**Convention on Road Signs and Signals of 1968**

**European Agreement Supplementing the Convention**

Group of Experts on Road Signs and Signals, WP.1, UNECE

M. Pronin, Consultant

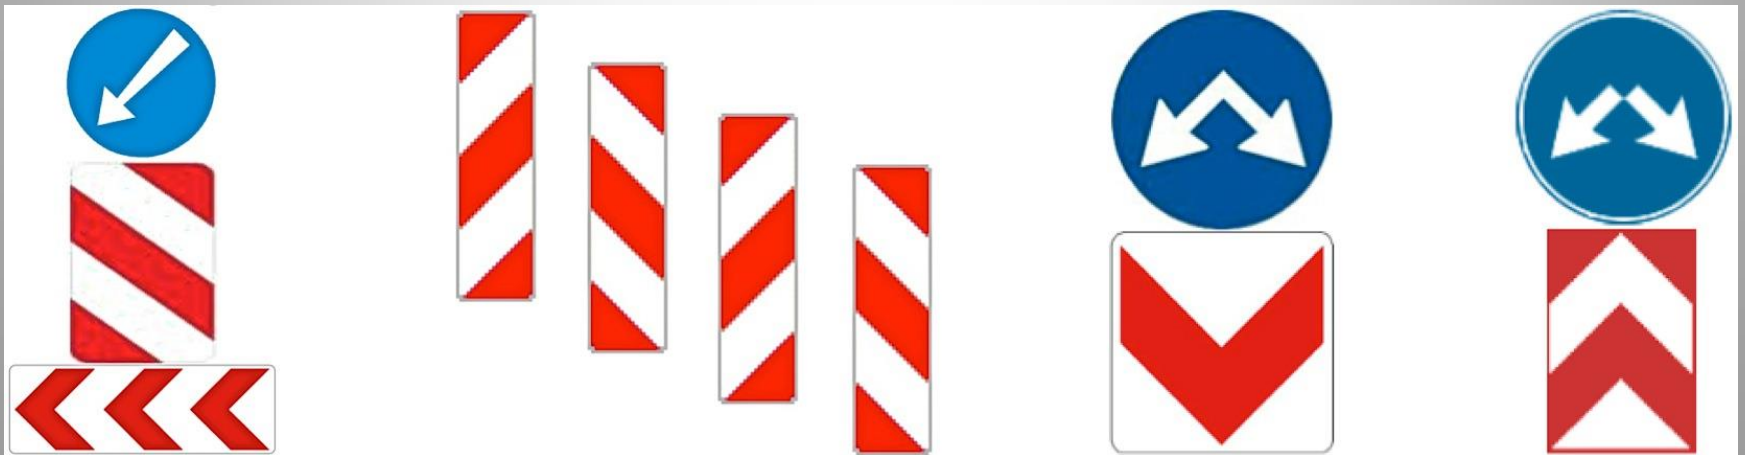
For U turn permitted, at least 19 countries use a blue roundel...

...because they base the sign on D, 1a.

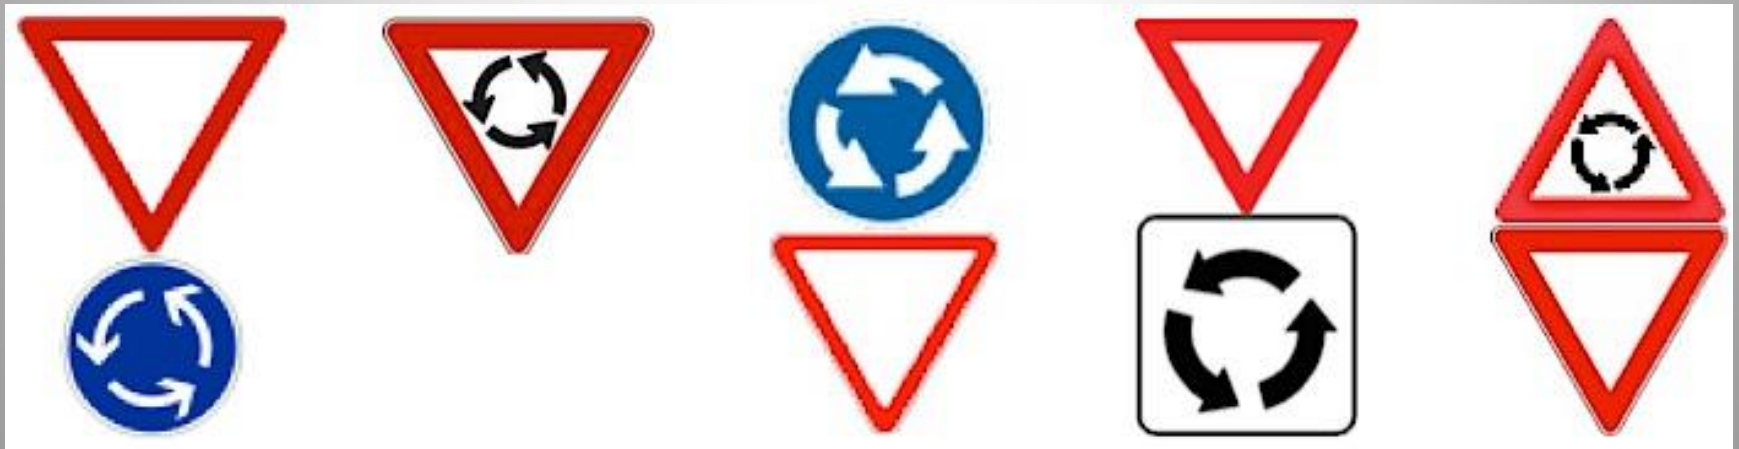
*Guidance is needed for sign assemblies.*

The VC often offers a choice: place panels on the top or bottom of the sign.
